Our Ref: 34918-002-01
Your Ref: OUT22/3480

Information Request Response
Development Application for Low Impact Industry
136 Crossland Road, Gordonvale – Lot 2 on RP747646

project
PROPOSED WORKSHOP
FOR :
UNINET ENCLOSURE SYSTEMS

Figure 1: Site plan containing nominated activity locations. Source: Brazier Motti

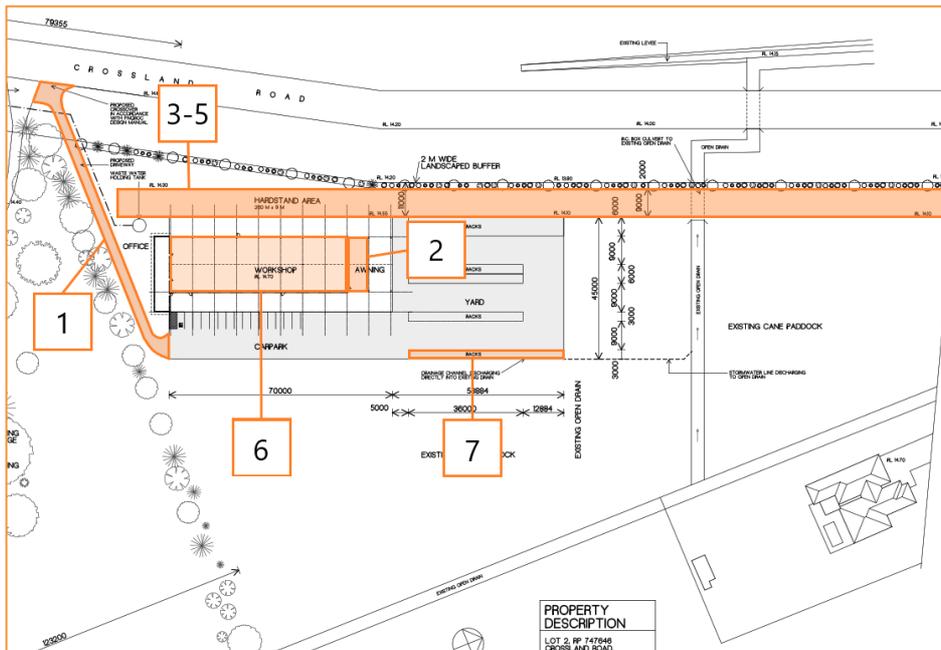
- The SDA application material does not provide a clear description of the process required for the repair and maintenance of the marine nets, the interrelationship between each stage of onsite operations nor does it describe movement throughout the site.

The proponent is requested to provide:

- A detailed description of the onsite operations and identify the location of each stage of the processes including delivery, washdown, cleaning, drying, repairing and storage.
- Further information to explain how the netting and inflatable beach structures are delivered to and transported around the site.

The process of onsite operations is relatively straightforward. *Figure 1* shows a site plan with the order and location of onsite operations labelled. *Figures 2 through 8* and associated descriptions provide the method in which nets are delivered, washed down, cleaned, dried, repaired and stored.

SITE PLAN

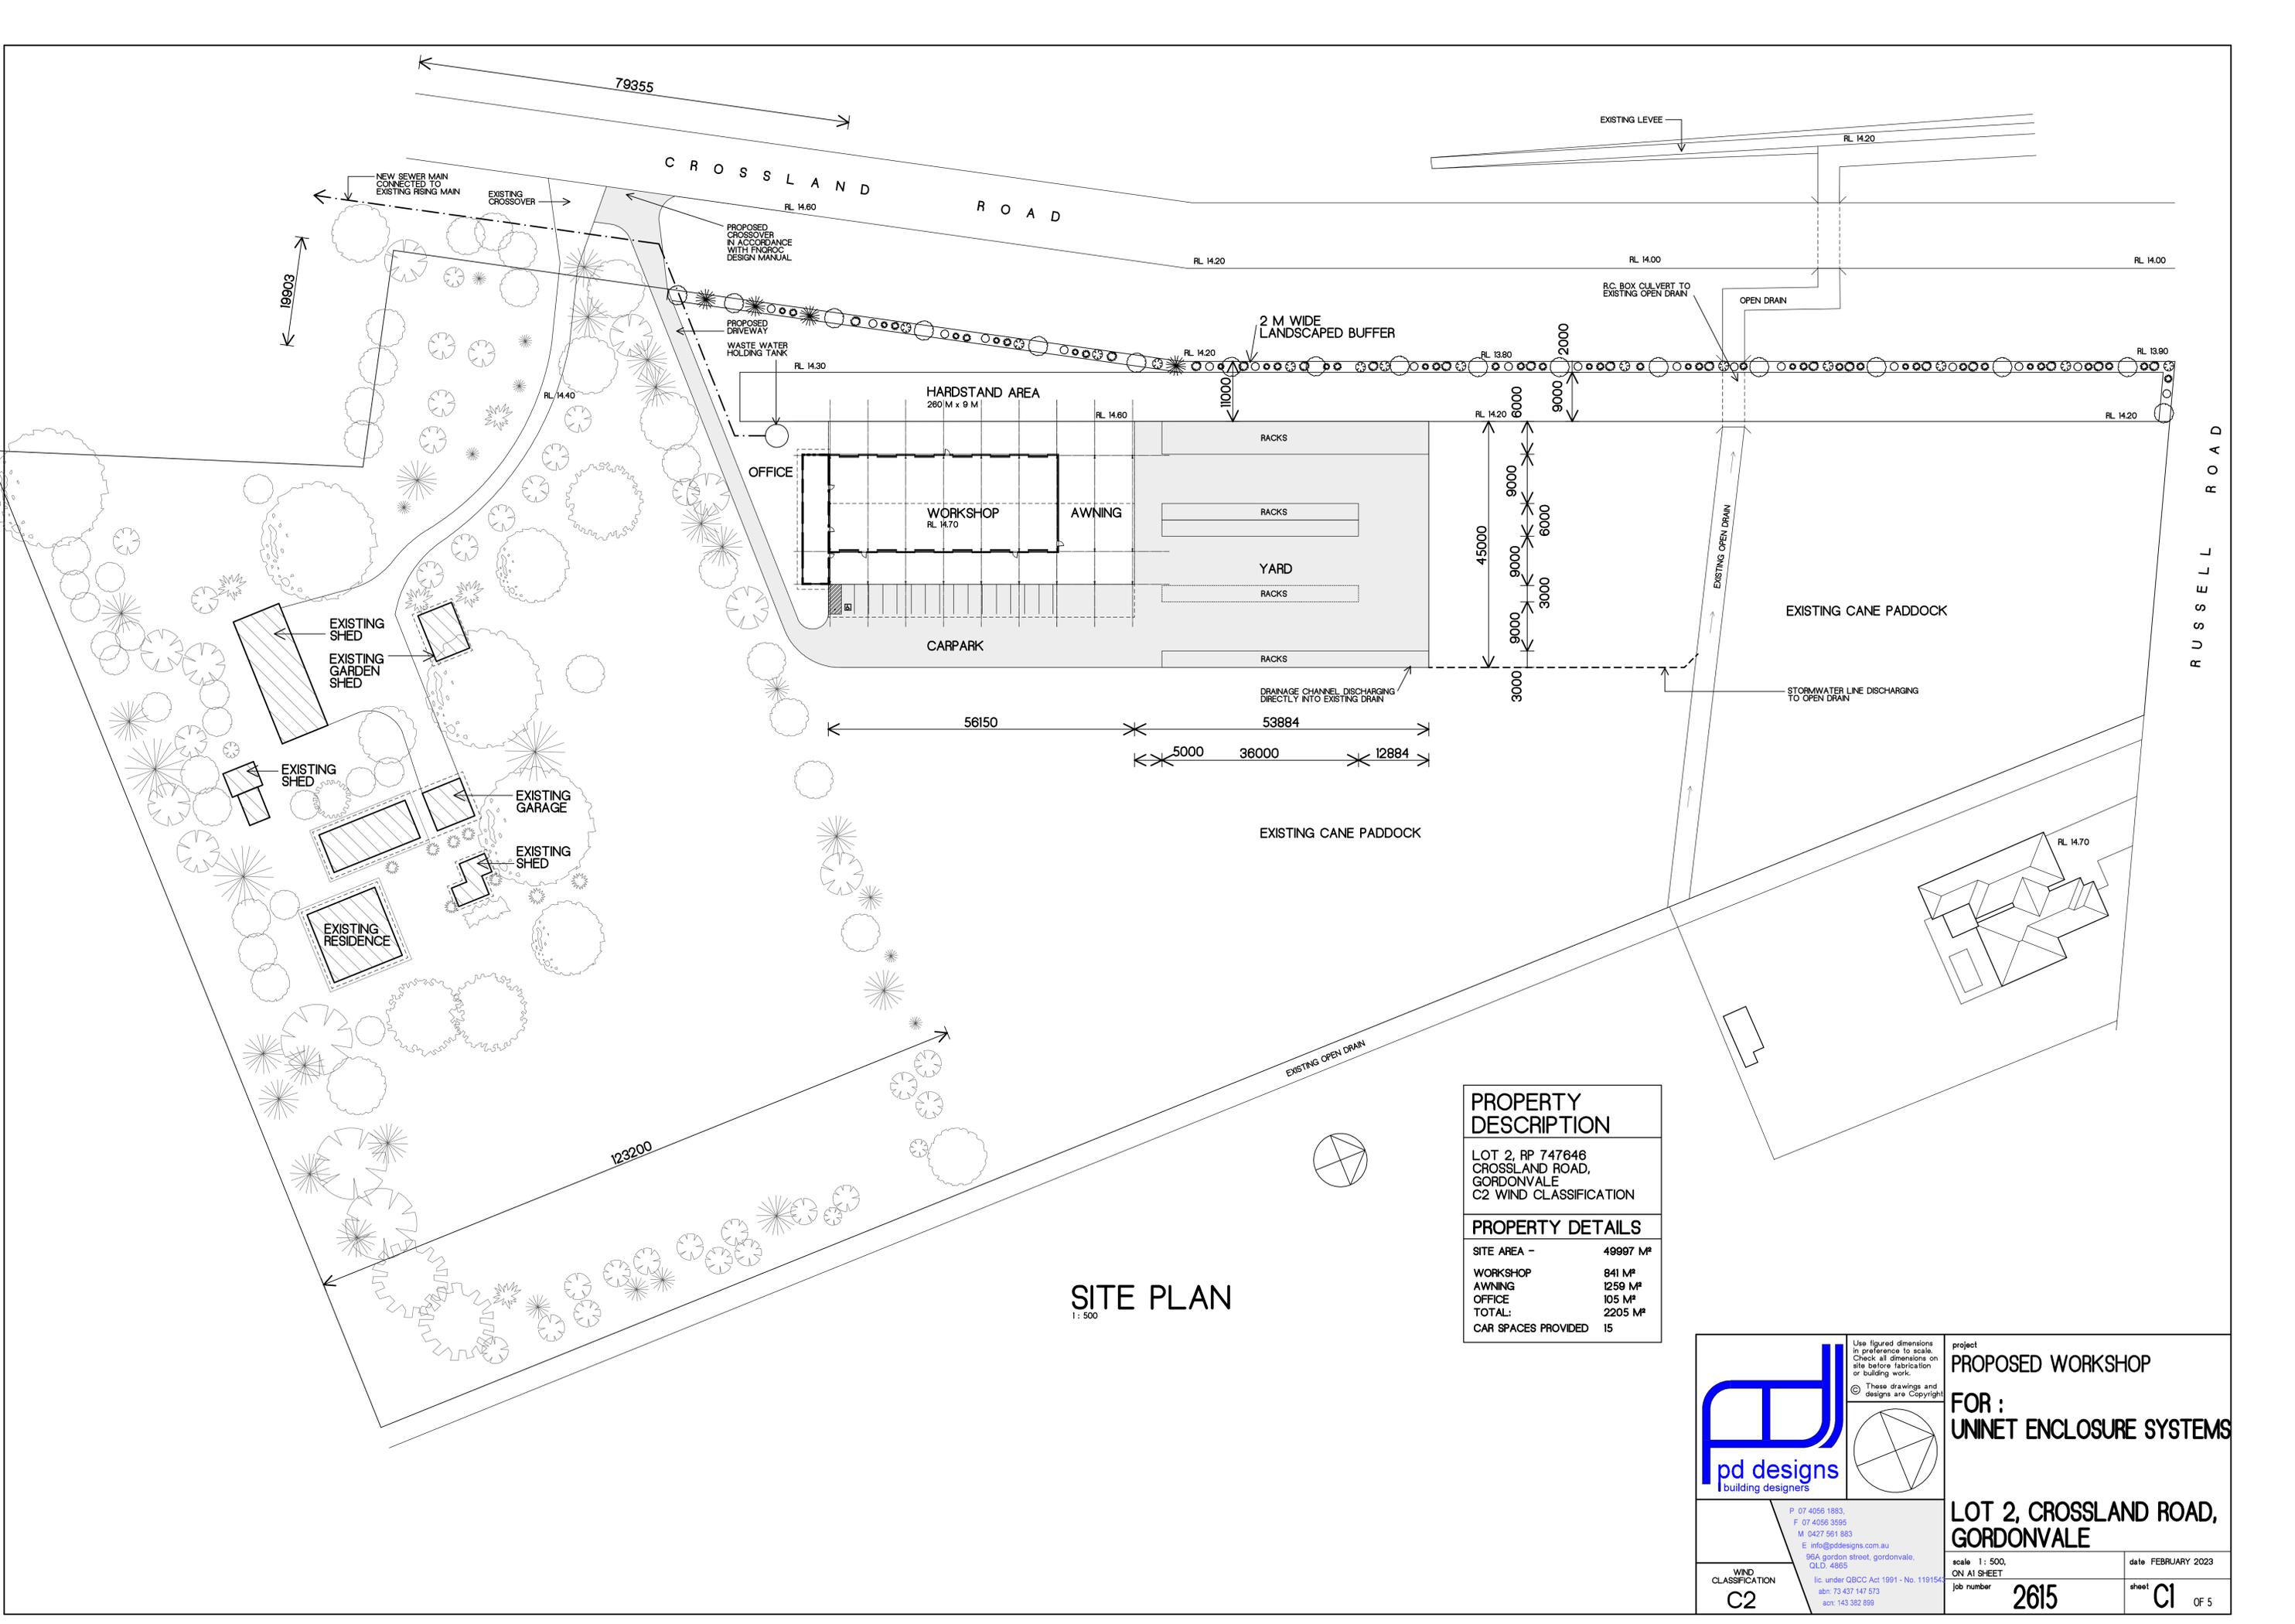
The proponent is requested to provide information on the type of stormwater strategies to be implemented and the proposed lawful point of discharge for the development, sneering the proposed strategies are consistent with Table 11 – Relevant engineering and design standards, of the development scheme.

7. *The development scheme's SDA wide assessment criteria requires development to be designed to facilitate safe and efficient vehicular ingress and egress and does not unduly impact on the safe and efficient operation of the use of an external road. Section 5.6 of the planning report outlines the expected vehicle movements and variety of vehicles to use an existing crossover however, the planning report does not provide sufficient detail regarding vehicle movement and frequency to allow for assessment.*

The stormwater strategy is for the site which slopes very gently to the East to be drained by a Drainage Channel along the Eastern perimeter discharging directly into the existing open drain. The roof stormwater would be collected by downpipes and piped to the drainage channel. These strategies are standard practice and would be detailed to the relevant engineering and design standards by a qualified engineer during detailed design. The layout is shown in the revised Design Plans included within Attachment D.

The proposed Landscaped Buffer shown in the Site Plan satisfies the Cairns Plan 2016 Planning Scheme Policy by providing a complete full length visual screen. Syzygium Australe species have proven very effective locally in achieving this objective. Significant screening at 2 years and complete screening to a height of 4 metres would determine the exact cultivar, spacing, irrigation and management plan.

The upgraded crossover and driveway shown within the revised Site Plan will be of a size and configuration that will facilitate all above vehicles to enter and exit the site without impeding on any traffic of Crossland Road. Most access movements are expected to be from the South (toward the Gordonvale highway) with the upgraded driveway most suited to this approach direction. The entrance gate will be set back from the transport corridor significantly to allow each vehicle to park while opening the access gate if necessary.

ELEVATION ①

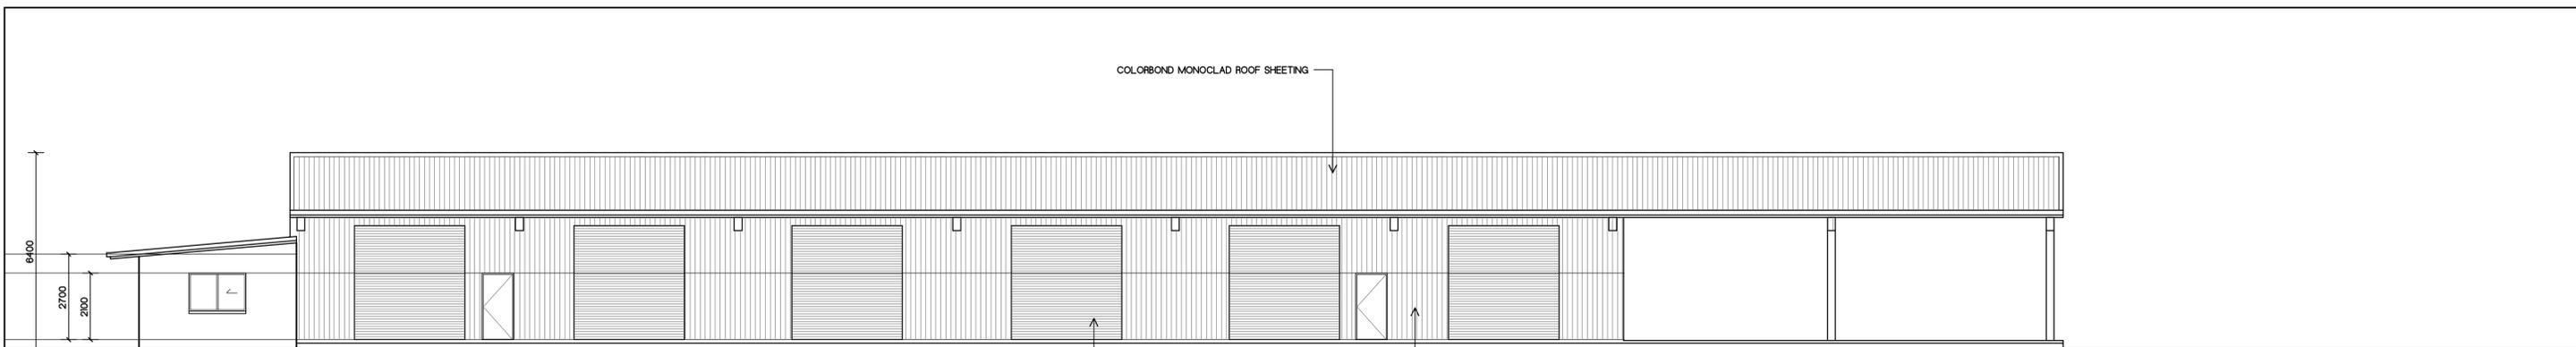
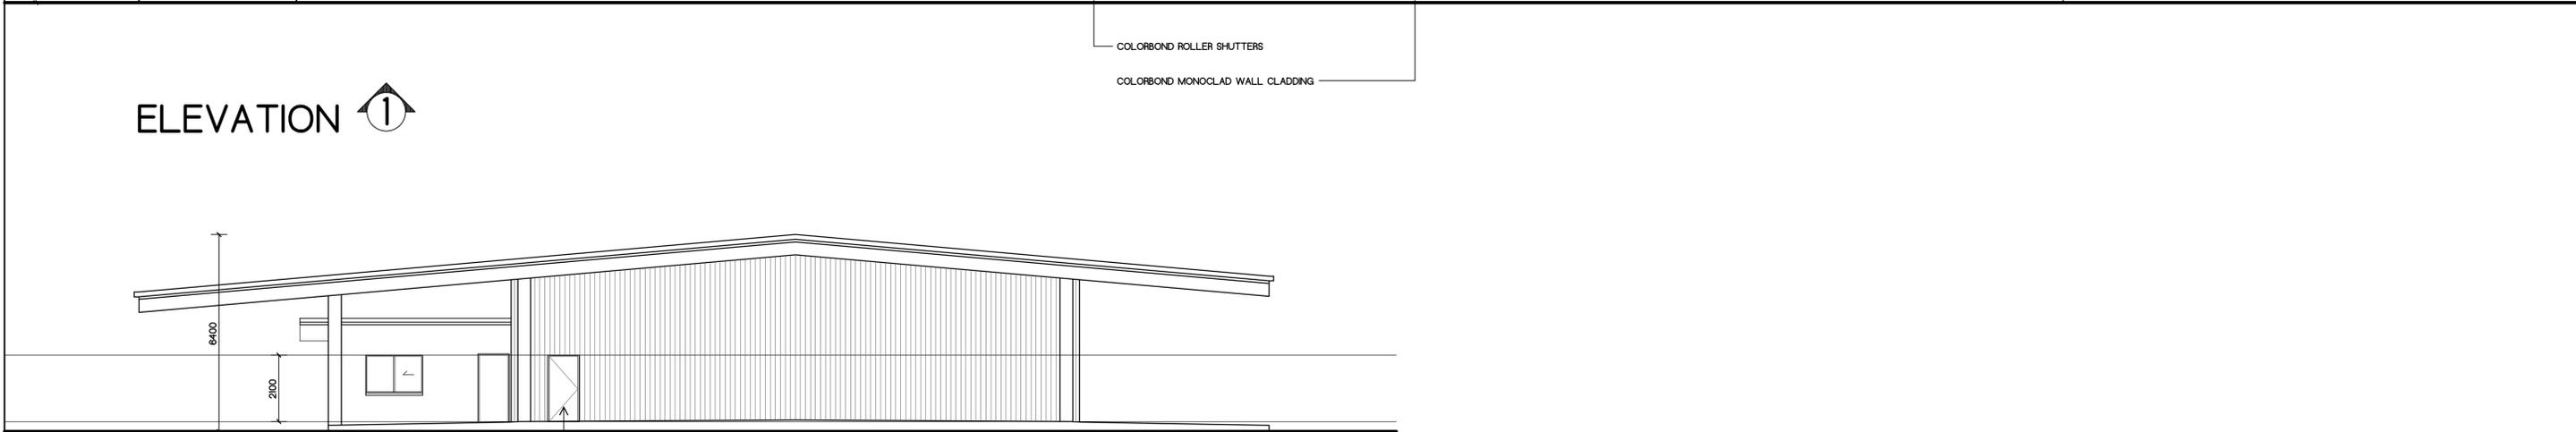
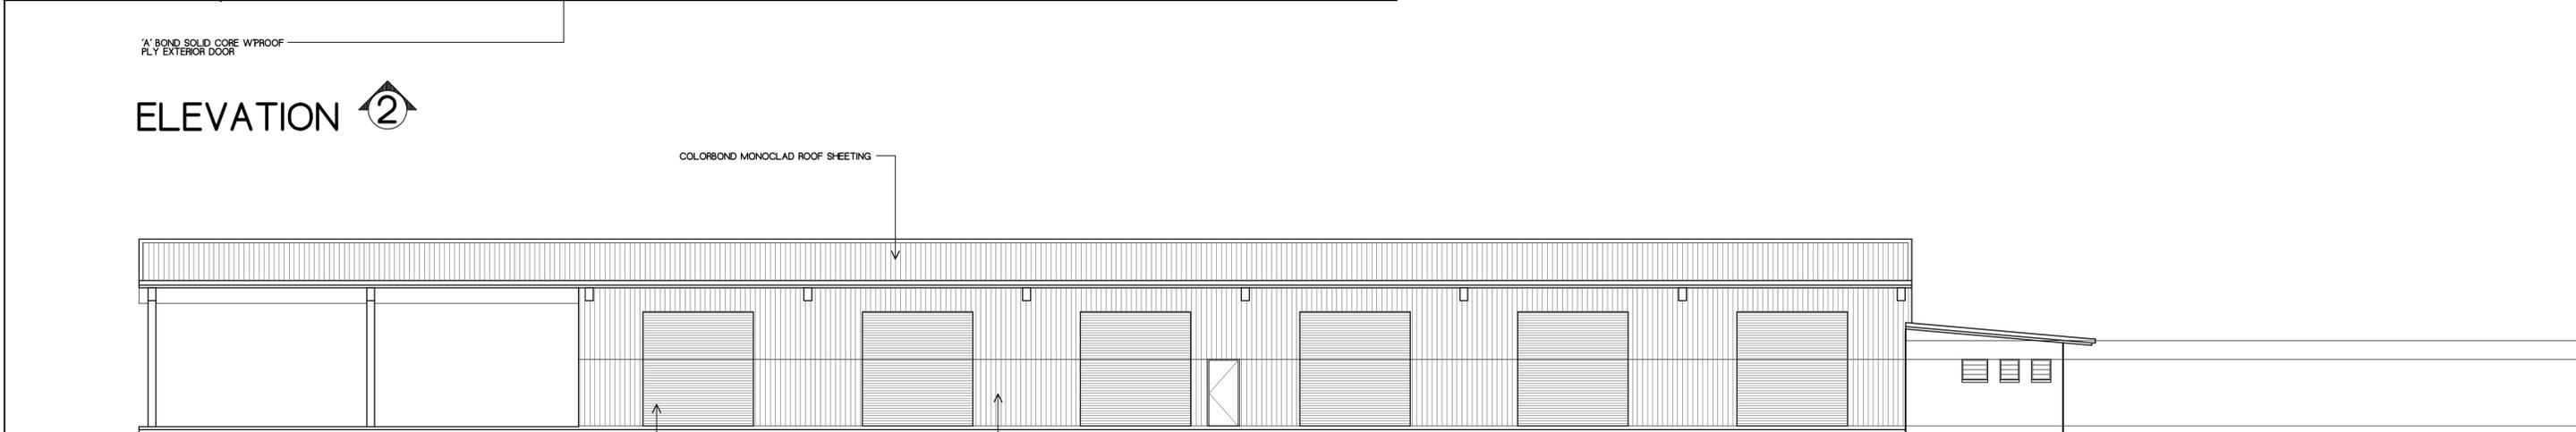
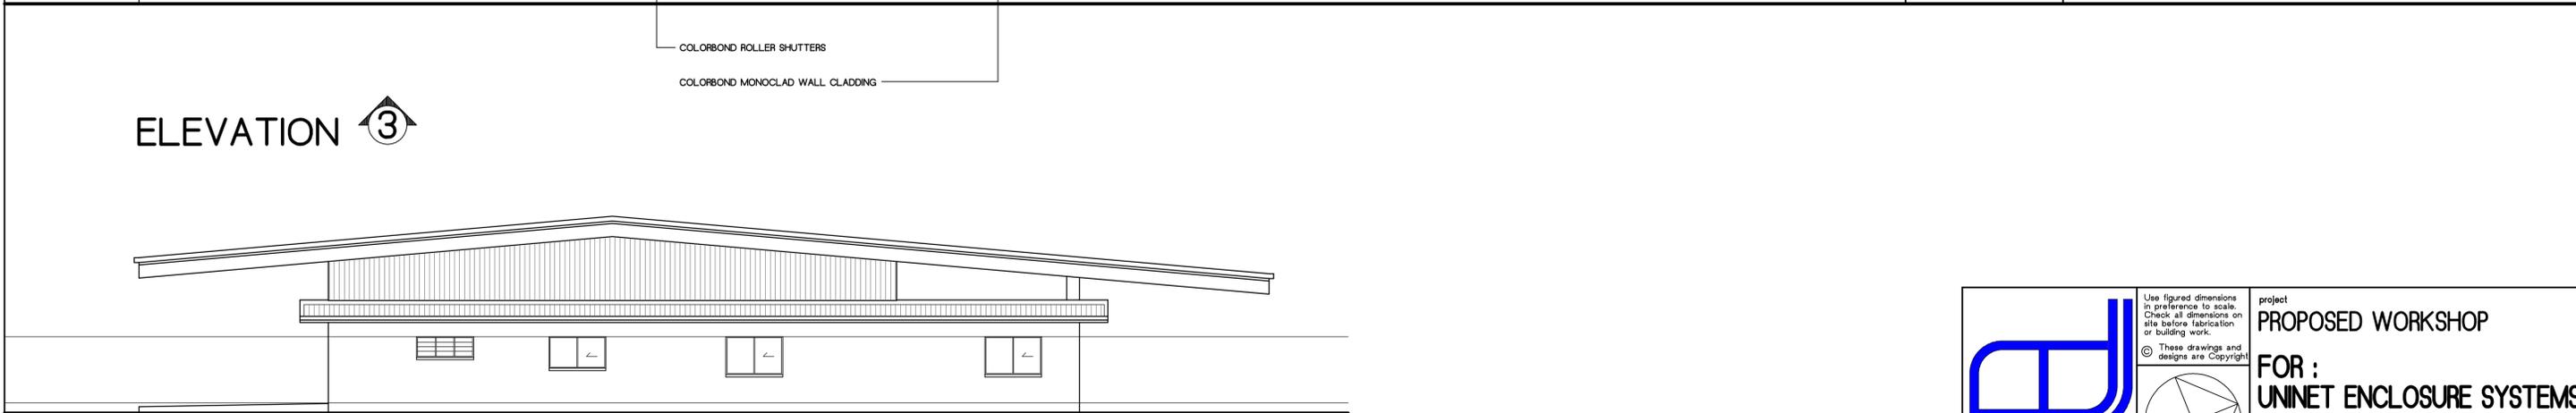
The SDA application material does not provide a comprehensive set of plans illustrating the bulk and scale of the proposed onsite structures in relation to the surrounding environment or explain the interrelationship and onsite functionality of the proposed development.

The proponent is requested to submit a revised set of plans clearly illustrating the following:

- (a) Elevations of the proposed development, including maximum building heights, site coverage, façade treatments and fenestration as well as external materials and finishes*
- (b) Surface treatments and pavement types*
- (c) Additional detail about the intended use of the subject site clearly identifying the location of each use*
- (d) Location of the washdown area and associated wastewater diversion channels*

Updated design plans depicting the additional information are included within Attachment D.

The Workshop, Awning and Hardstand Area will be concrete surfaces. The Driveway, Carpark and Yard will be asphalt surfaces. The proposal includes buildings and structures consistent with those commonly utilised for agricultural purposes in keeping with the built form and general amenity of the rural area;
